Re: RI-FS Work Plan Addendum  
Special Metals Corporation  
100 Willowbrook Avenue  
Dunkirk, New York  
Site # 907031  
Order on Consent and Administrative Settlement (Index# B9-0737-07-02)

**SPECIAL METALS CORPORATION**  
 DUNKIRK FACILITY  
 100 WILLOWBROOK AVENUE  
 DUNKIRK, NEW YORK  
 IRM ADDENDUM LETTER  
 OVERALL SITE PLAN AND  
 REVISED AREA OF CONCERN

FIGURE No.  
**1**

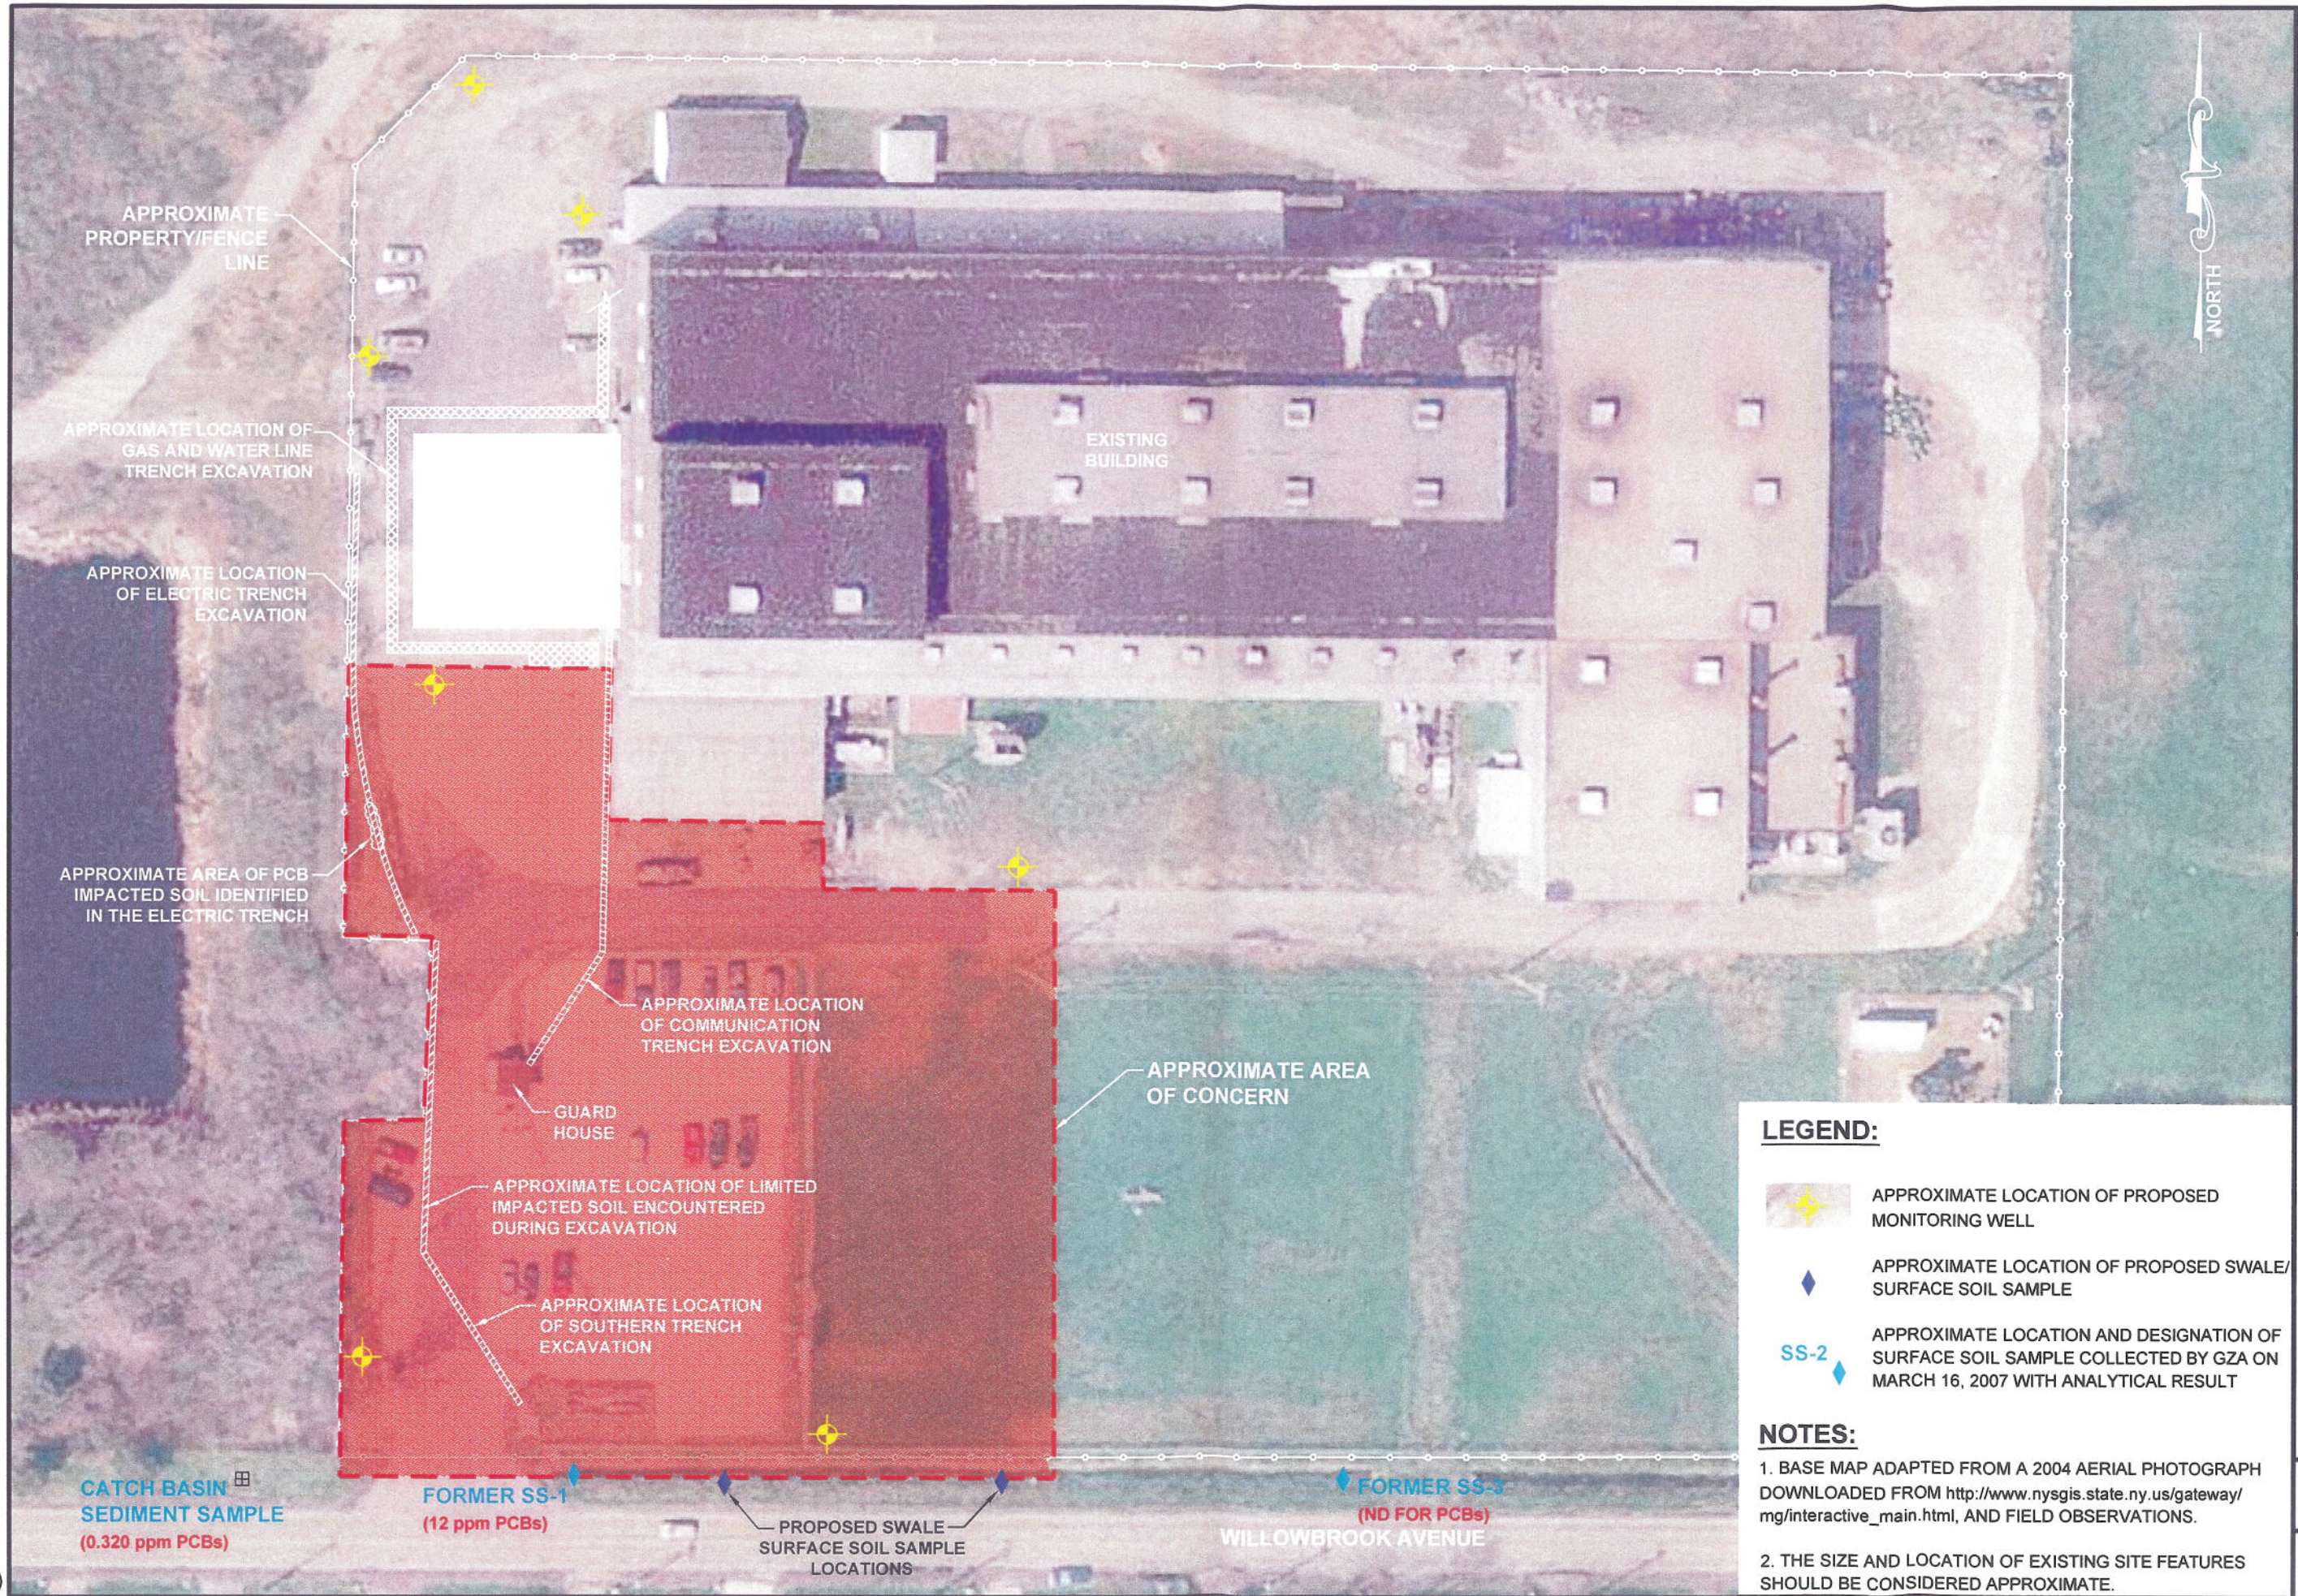
We propose to modify the monitoring well locations proposed in the RI/FS Work Plan to cover the expanded AOC as shown in the attached Figure 1. The monitoring wells would be installed as proposed in the RI/FS Work Plan at the revised locations.

A sediment sample was also collected from a downstream catch basin (approximately 120 feet from drainage swale sample location SS-1) located to the west, which receives storm water from the drainage swale (see Figure 1). The analytical sample results indicated that PCBs were present at a concentration of 0.230 ppm. Copies of the analytical reports from these two sampling results are enclosed.

Although the apparent limits of PCB contamination in the swale area have been determined in a westerly direction, two surface soil samples are proposed to be collected at the locations shown on Figure 1 to delineate potential PCB contamination to the east of the SS-1 location.
